To: Incardine, Joseph[jincardi@blm.gov]
Cc: Staszak, Cynthia[cstaszak@blm.gov]; Matthew J Betenson[mbetenso@blm.gov]; Amber Hughes[ahughes@blm.gov]; Harry Barber[hbarber@blm.gov]; Ellen Hopp[ellen.hopp@galileoaz.com]
From: Angus, Allysia
Sent: 2017-03-09T12:42:38-05:00
Importance: Normal
Subject: Re: Lake Powell Pipeline project- Meeting this Friday
Received: 2017-03-09T12:43:13-05:00
[16 - Visual Resources Study Report FINAL conformance pages.pdf](#)
[Visual Resources Study Report FINAL KOP13 Toadstools TH Contrast Rating.pdf](#)
[Visual Resources Study Report FINAL KOP14 Toadstools TH Contrast Rating.pdf](#)
[Visual Resources Study Report FINAL KOP20 HS-1 Contrast Rating.pdf](#)
[Visual Resources Study Report FINAL KOP28 Kanab Creek Contrast Rating.pdf](#)

I just reviewed the VRM Final Study Report provided by Maria at Galileo on a thumbdrive (much appreciated and easy to work with).

According to this document the following locations are noted as not meeting VRM objectives:

KOP: 14 **VRM: Class 2**
 Toadstools Trailhead

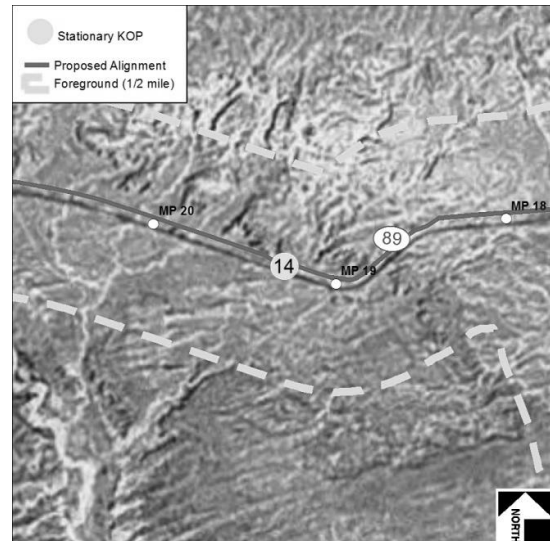
KOP 13 - Pipeline east along Highway 89 near Toadstools Trailhead (GSEMN)
KOP 14 - Pipeline West of Toadstools Trailhead (GSENM)
KOP 20 - HS-1 from Highway 89 (GSENM)
KOP 28 - Pipeline Kanab Creek {Kanab Creek ACEC} (AZ Strip FO)

Does project design meet visual resource objectives? ☐ Yes ☒ No

Additional mitigation measures recommended? ☒ Yes ☐ No

Additional mitigation as included in Chapter 5, as well as site specific mitigation identified in POD.

KOP: 28 **VRM:** Class 2
 VRM: Class 3
 VRM: Class 4

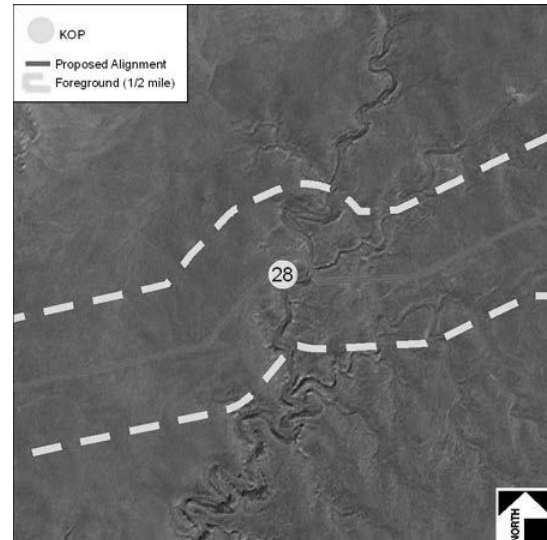
Does project design meet visual resource objectives? ☒ Yes (Class 3 and 4) ☒ No (Class 2)

Additional mitigation measures recommended? ☒ Yes

☐ No
Additional mitigation as included in Chapter 5, as well as site specific mitigation identified in POD.
